ADDENDUM NO. 1, DATED JULY 27
TO THE DOCUMENTS FOR
UNCC RENOVATIONS TO FOUNDATION ANNEX SUITE 8730
SCO # 16-12984-01A
UNIVERISITY OF NORTH CAROLINA AT CHARLOTTE
CHARLOTTE, NORTH CAROLINA
COMM. NO. 17009.00

SHEET E0.04: ELECTRICAL DETAILS

SHEET E0.05: EQUIPMENT SCHEDULES, PANELS AND RISER DIAGRAM

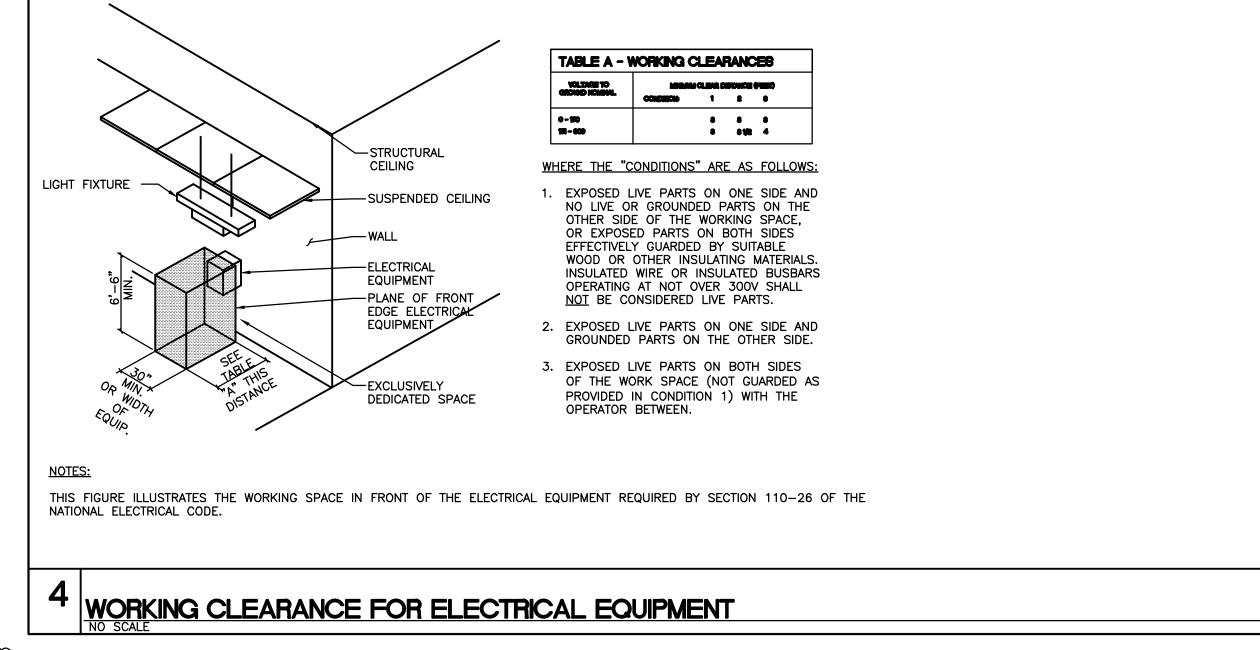
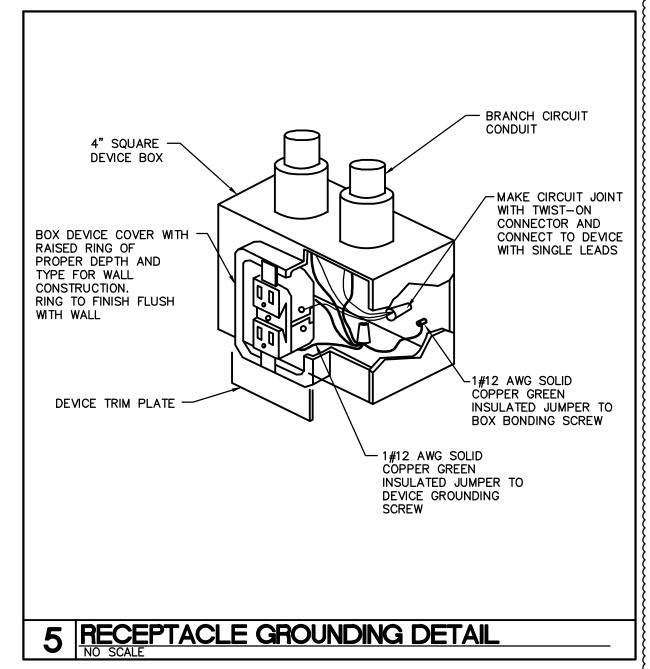
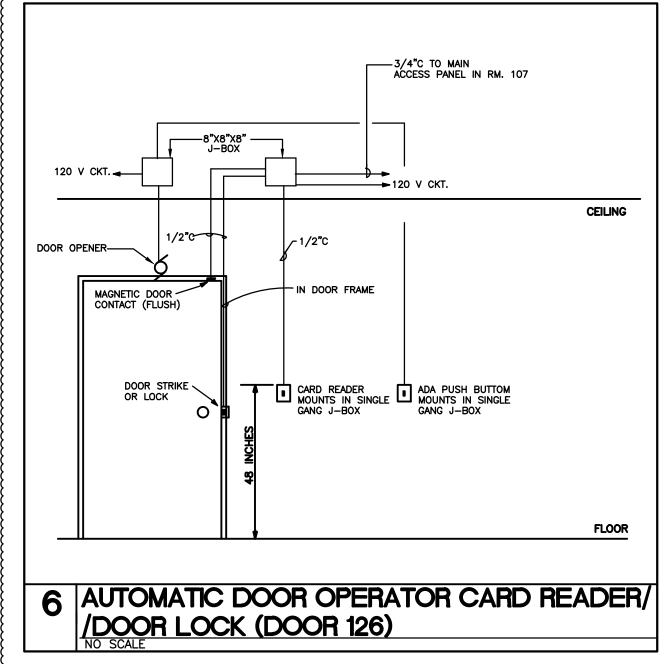
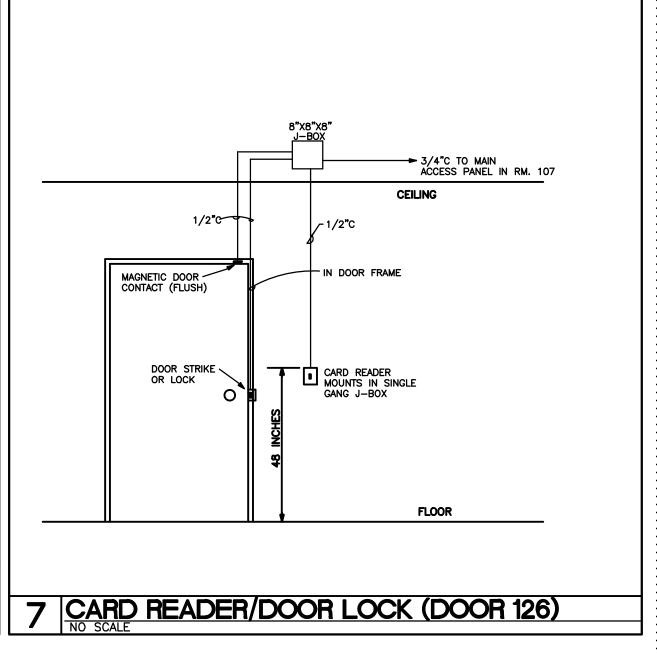
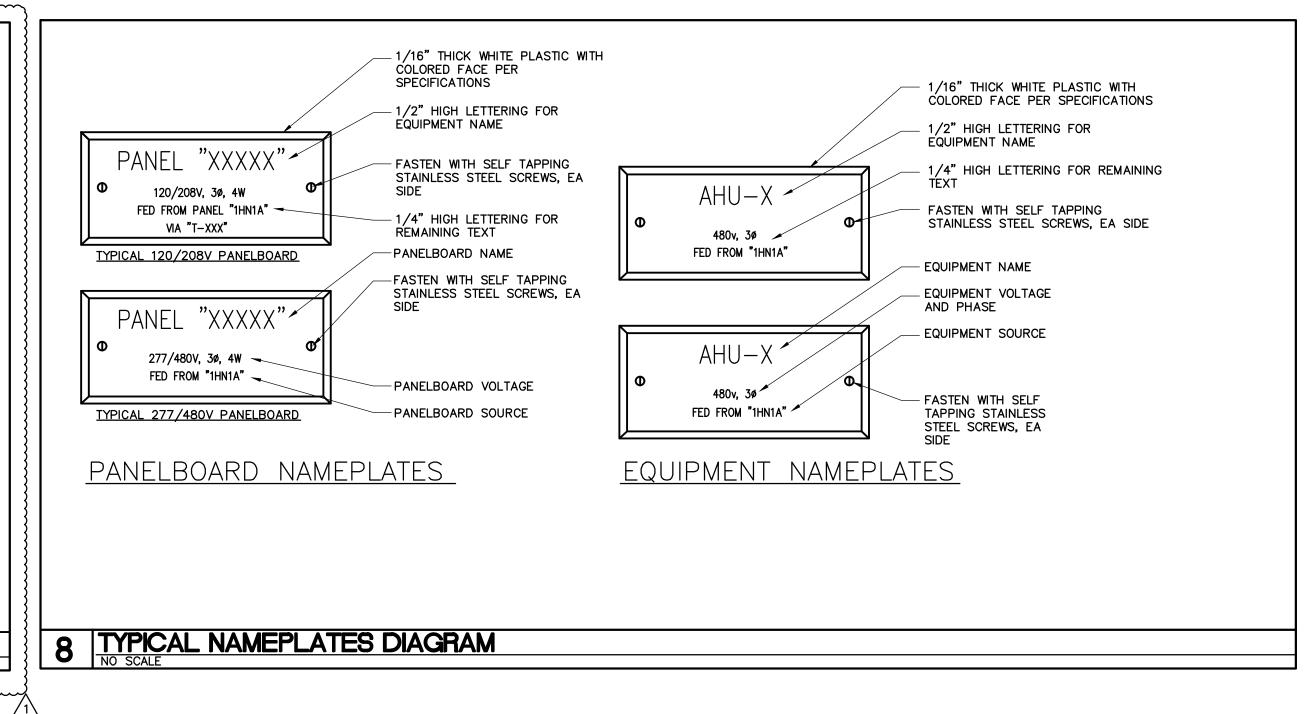
4. Details 6 and 7 on this sheet have been revised. The sheet with Revision #1, dated 7/27/2017 is attached.

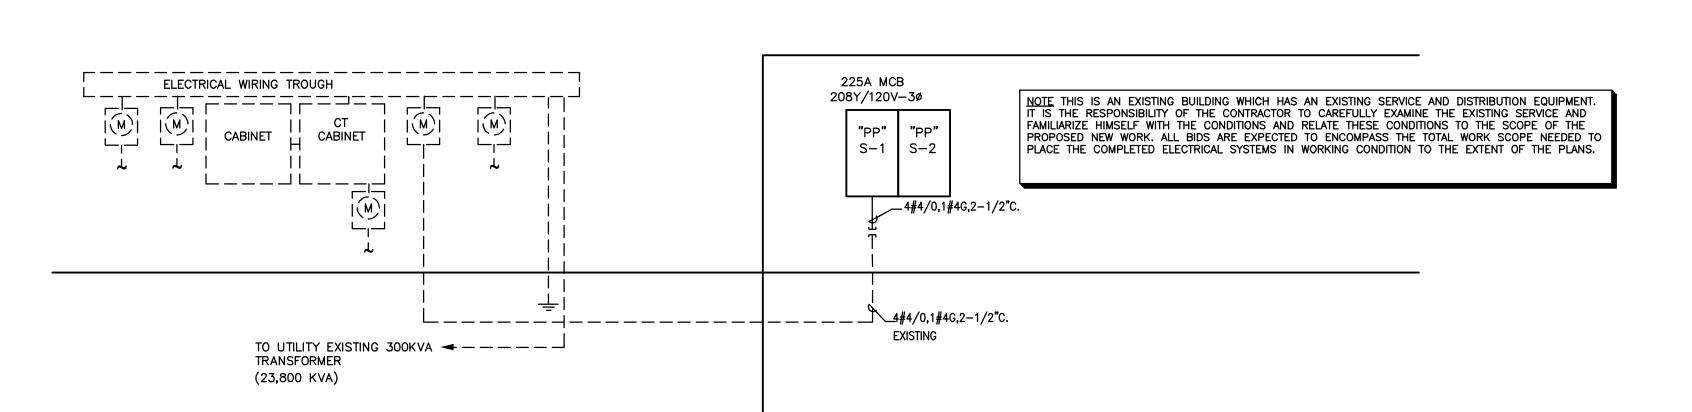
5. The Light Fixture Schedule and Detail 2 on this sheet have been revised. The sheet with Revision #1, dated 7/27/2017 is attached.
